TITLE : Modification of Pointer Processing Flow Chart

TITLE : Addition Monitoring Points in HPOM/LPOM Functions

TITLE : Considerations of loss priority between H.22x (Multimedia Multiplex including MPEG-2 Systems) and AAL type 1/2.

(FIGURE 2-8/G.783)

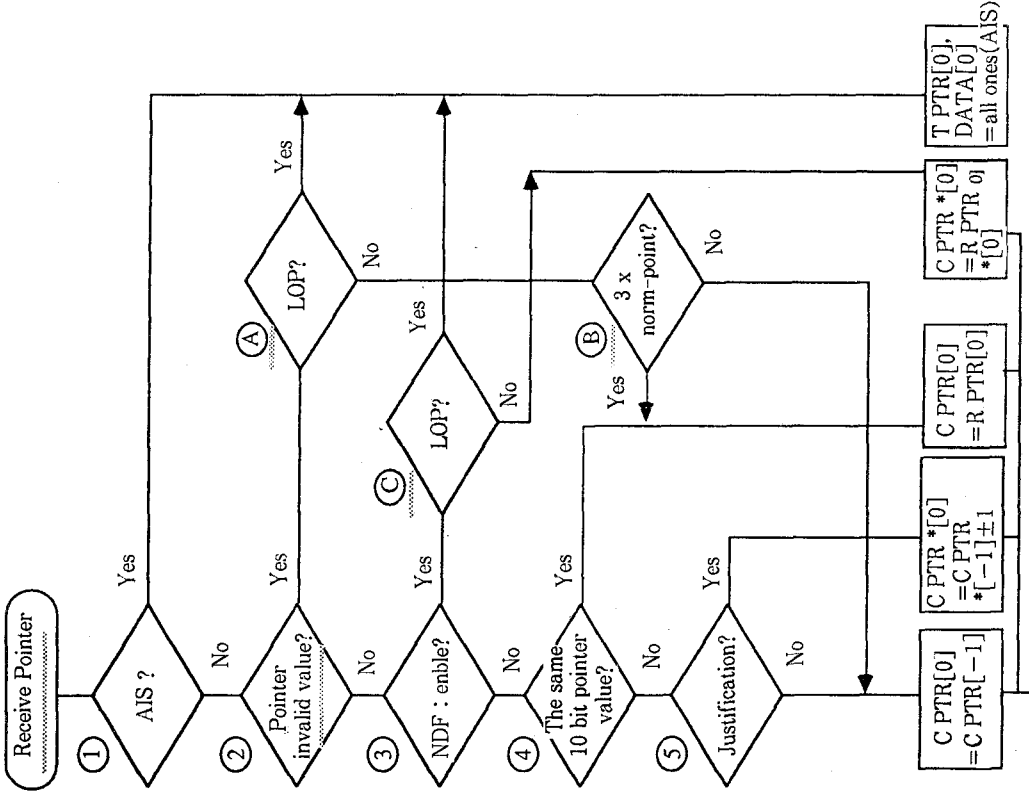
2.1 권고안 G.783의 부록 B는 AU 및 TU신호에 같이 적용될 수 있도록 되어 있으나 G.783의 그림 2-8에 있는 포인터 프로세싱 흐름도는 AU신호만을 위한 것 같이 명기되어 있다.

2.2 권고안 G.783의 부록 B에 의하면 Inv-point의 수신으로 인해 LOP-state로 천이하기 위해서는 Inv-point가 N 개 ($8 < -N < -10$) 연속적으로 수신되어야 하나 G.783의 그림 2-8에 있는 포인터 프로세싱 흐름도에서는 단지 하나만의 Inv-point수신에 의해서도 LOP-state로 천이할 수 있는것 같이 나타나 있으므로 N 개의 Inv-point가 연속적으로 수신되는지를 검출하는 과정이 하나 추가 되어야 한다.

위에서와 같은 정의들을 바탕으로 하면 LOP-state로 천이하기 이전에 3 x norm-point가 Inv-point보다 우선권을 가지므로 3 x norm-point에 대한 검출 과정이 추가되어야 한다.

2.4 포인터 해석 다이어그램에는 N x NDF-enable이 NORM-state로 부터 LOP-state로 천이할 수 있도록 해 두었으나 포인터 프로세싱 흐름도에는 이것이 반영되어 있지 않으므로 추가 되어야 한다.

포인터 검출 알고리즘과 포인터 프로세싱 알고리즘 간의 일관성을 부여하고 포인터 프로세싱의 정상동작을 위한 기준을 마련하기 위해 한국은 현재의 포인터 프로세싱 흐름도에 그림-1과 같이 A, B, C 세개의 판단 과정을 추가하고 포인터 프로세싱 흐름도가 AU 및 TU에 모두 응용될 수 있도록 하는 것을 제안한다.

(Figure-1)

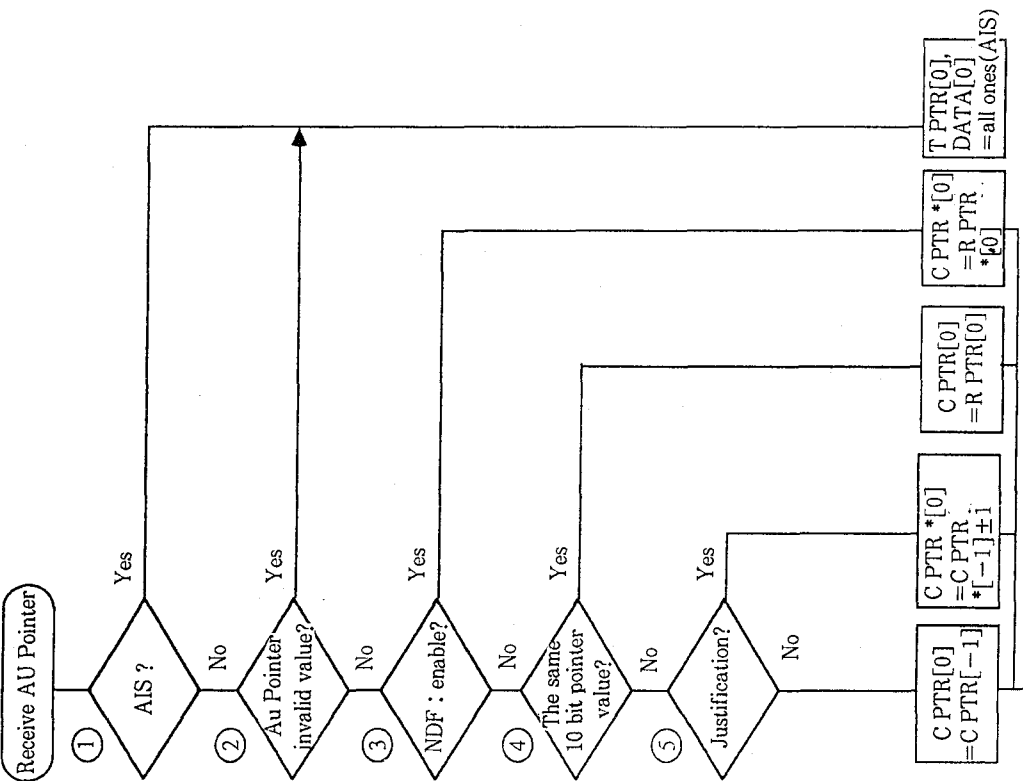
2.1 ANNEX B to Recommendation G.783 is for both TU and AU, whereas pointer processing flow chart(FIGURE 2-8/G.783) tends to be recognized as a flow only for AU because notes "Receive AU pointer" and "AU pointer invalid value?" are used.

10) consecutive Inv-points are received, where as the flow for pointer interpreter in FIGURE 2-8/G.783 shows that only one invalid AU pointer value may insert all ones. There are many cases of pointer errors except N consecutive Inv-points. Thus a step to decide whether to enter into the LOP-state or not is needed.

Based on those definitions and a note before entering into a LOP-state from the receptions of Inv-points, because 3 x norm-point has the precedence over Inv-points, one routine to detect 3 x norm-point with normal NDF(i.e.norm-point with offset value not equal to active offset) is needed.

2.4 Pointer interpretation diagram shows that N x NDF-enable makes a transition from NORM-state to LOP-state, But in FIGURE 2-8/G.783, the step for this is not considered. Thus one more decision step is needed in FIGURE 2-8/G.783.

To maintain the consistency between pointer detection algorithm(ANNEX B to Recommendation G.783) and pointer processing flow chart(FIGURE 2-8/G.783), Korea proposes to add three more decision steps(A, B, C) to the part of the flow for pointer interpreter in FIGURE 2-8/G.783 as shown in the following Figure-1 and to generalize pointer processing flow chart for both TU and AU.

Current signal interaction in FIGURE 2-2/G.782
(HPOM, LPOM)

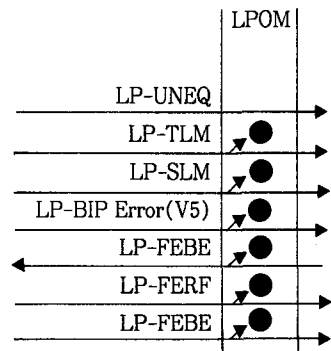
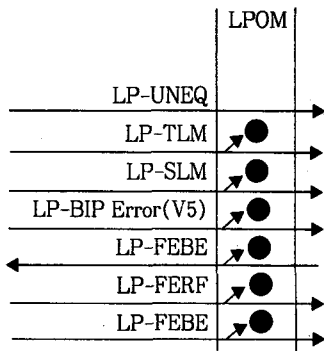
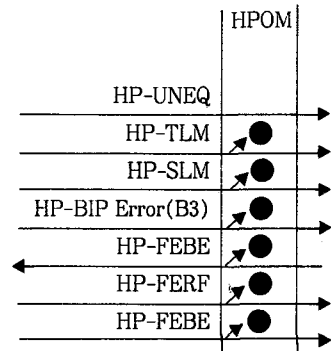
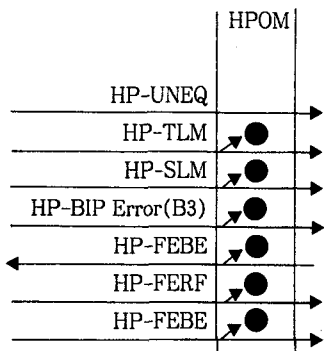
G.782에 있는 유지보수 신호 상관 관계도에는 HPOM에서 Higher order Unequipped Signal(HP-UNEQ)을 감시하지 않는 것으로 표시 되어 있으나 G.782의 2.2.4와 G.783의 2.6.1 그리고 G.783의 2.6.2에서 정의된 HPOM과 HUG의 기능을 기본으로 하면 HPOM에서 HP-UNEQ를 검출하는 것이 타당하다고 여겨진다.

2.2 또한 현재 G.783은 HUG와 LUG에서 경로 신호 라벨을 “UNEQUIPPED”로 세트하기 위해서는 기준점 G 및 K(HPC, LPC)에서 open state를 마련해 주어야 하는 것으로 정의하고 있으나 HPC와 LPC의 스위치 매트릭스는 전송망 plan과 관련된 부분이며 SEMF에 의해 reconfiguration될 수 있도록 하는 것도 타당하다고 여겨진다.

상기 기술된 HPOM과 LPOM의 기능이 SDH 유지보수 신호 상관관계 도표에서 설명될 수 있고 HCS와 LCS의 스위치 매트릭스의 운용 효율을 높일 수 있도록 하기 위해 한국은 G.782의 그림 2-2에서 HPOM과 LPOM에서 미사용(unused)신호에 대한 감시점을 제공하고 기준점 S18과 S19의 제어에 의해 HCS와 LCS의 스위치 매트릭스를 조절 할 수 있도록 제안한다.

→ Receiving an “unequipped” signal at reference point G and control signals from S18,

→ Receiving an “unequipped” signal at reference point K and control signals from S19,

Current signal interaction in FIGURE 2-2/G.782
(HPOM, LPOM)

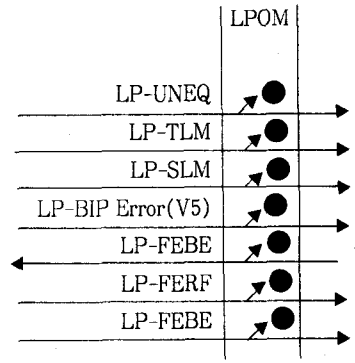
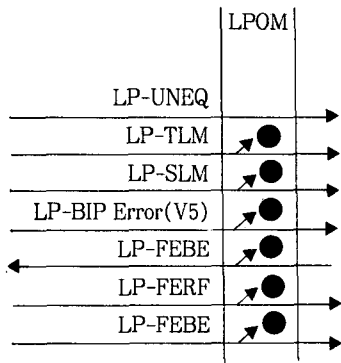
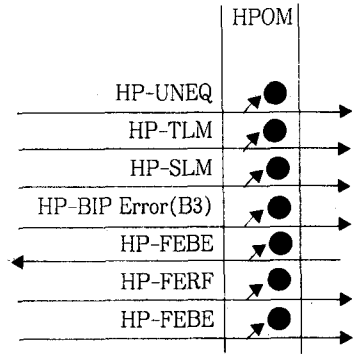
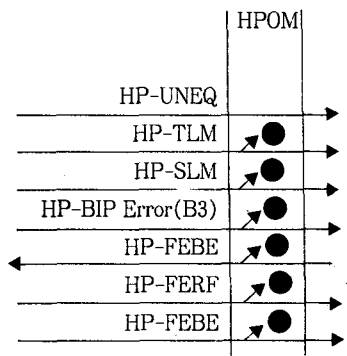
The FIGURE 2-2/G.782 for SDH maintenance signal interaction shows that Higher order Unequipped signal(HP-UNEQ) is not monitored as one of the HPOM functions. But the description in section 2.2.4 of G.782, the Note in section 2.6.1 of G.783, and the paragraph in 2.6.3/G.783 imply that Higher order Unequipped signal(HP-UNEQ) monitoring function is required as one of the HPOM functions.

2.1 According to the descriptions below, HCS is used to generate “unequipped” VC paths between network elements, where HUG generates “unequipped” signal by detecting the open state of the HPC, and HPOM, in turn, needs to detect HP-UNEQ to terminate(monitor) the “unused” connection.

2.2 And the current conditions for HUG and LUG to set the path signal label to “UNEQUIPPED” are provided by the open states of HPC and LPC, respectively(reference points G and K). Considering that the configuration of switch matrix of HPC and LPC is dependent on the network plan, to provide the possibility for the switch matrix to be reconfigured by the demand of SEMF is needed.

To make it possible for those descriptions explained in the SDH maintenance signal interaction and to keep switch matrix utilization ratio high, Korea proposes to add unequipped signal monitoring points to HPOM and LPOM in FIGURE 2-2/G.782. And addition of reference points S18 and S19 from SEMF to make it possible for HUG/LUG functions set the path signal label to “UNEQUIPPED” is also proposed as follows.

→ Receiving an “unequipped” signal at reference point G and control signals from S18,

→ Receiving an “unequipped” signal at reference point K and control signals from S19,

[그림 1] Protocol Configuration in the audiovisual communication terminal

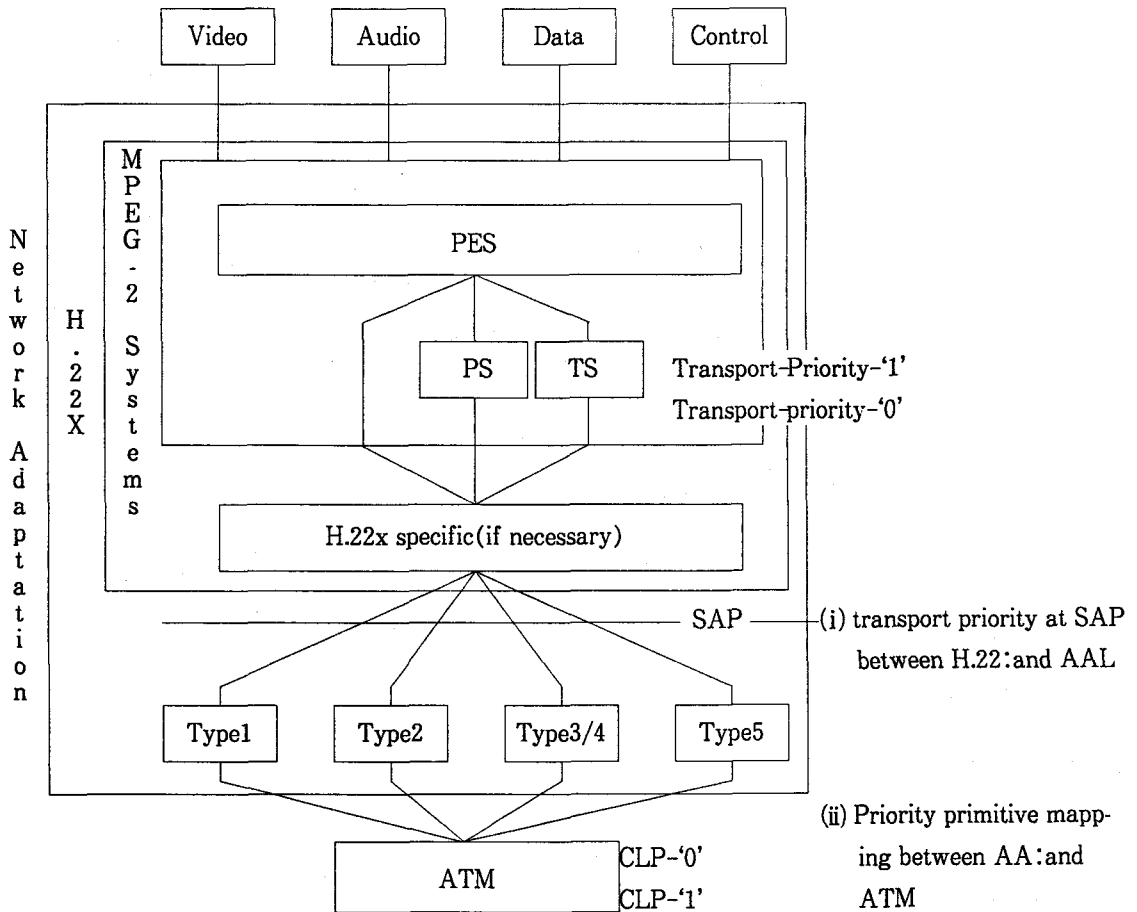
그림 1에서는, 188 바이트로 구성된 전송스트림이 MPEG-2 시스템을 ATM 망에 접속하기 위하여 H.22x를 거쳐 AAL로 전송된다. 전송스트림의 전송우선순위 1비트 필드가 할당되었고, 전송우선 순위 필드가 '1'로 설정되었을 때, 이는 관련된 다른 패킷 보다 우선순위를 가짐을 나타낸다. 망에서 혼잡이 일어날 경우, 높은 우선순위를 갖는 전송스트림은 망에서 폐기를 고려하여야 하며, 셀 폐기로 인한 화질의 저하를 적절히 방지할 수 있다. 전송 스트림이 H.22x를 거쳐 AAL로 전송될 때, H.22x와 AAL type 1/2사이의 서비스 접속점(SAP)에서 이를 수용할 프리미티브가 설정되어 있지 않다. 따라서 이에 대한 프리미티브가 제시되어야 한다. 예로, 우선순위를 갖는 전송스트림은 우선순위를 갖는 셀(CLP='0')에 매핑되어야 한다.

-H.22x와 AAL 1/2 사이의 우선순위 프리미티브 삽입.

이 경우, ATM 계층의 CLP 비트가 전송 스트림 계층에서 전송 우선순위를 제공할 수 있는지에 대한 고려를 하여야 한다.

[Figure 1] Protocol Configuration in the audiovisual communication terminal

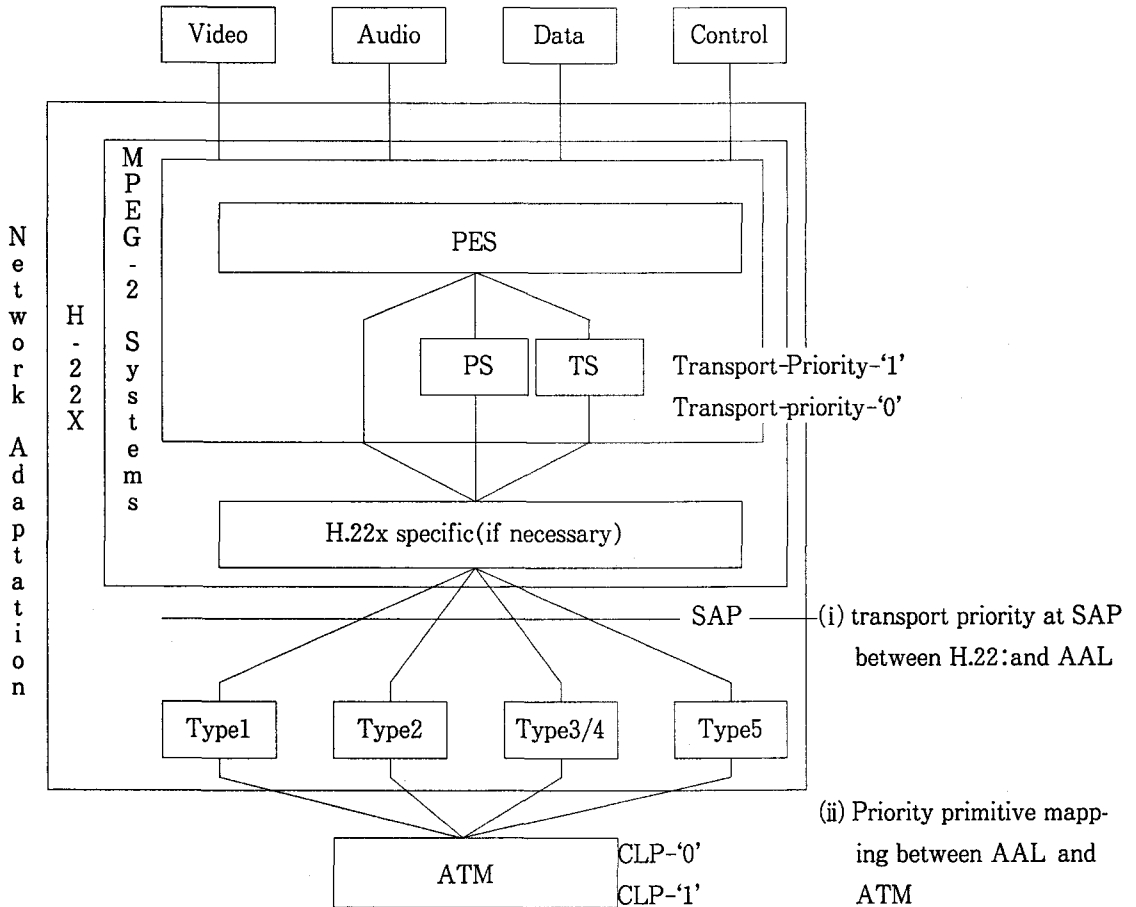
As shown in Fig. 1, the transport streams with 188 bytes are transferred to AAL through H.22x (if necessary) in order to interface the MPEG-2 systems into the ATM network. One bit in the field format of the transport stream is assigned for the transport priority. When the transport priority field set to ‘1’ it indicates that the associated packet has high priority. When the network congestion occurs, the transport stream with high priority should not be discarded inside the network and then the deterioration of video quality due to discarding the cells could be protected within the acceptable level.

When the transport streams are transferred to AAL via H.22x specific (if necessary), there are no primitive to send their transport priority in AAL-PDUs at service access point (SAP) between H.22x and AAL type 1/2. It may also need the priority primitive mapping between AAL 1/2 and ATM layer. An example is that the transport streams with high priority are generated into the cell streams with high priority (CLP=0).

-The insertion of priority primitive between H.22x and AAL 1/2.

In this case, it should consider whether the CLP bit in the ATM layer is used to support transport priority in transport stream layer.
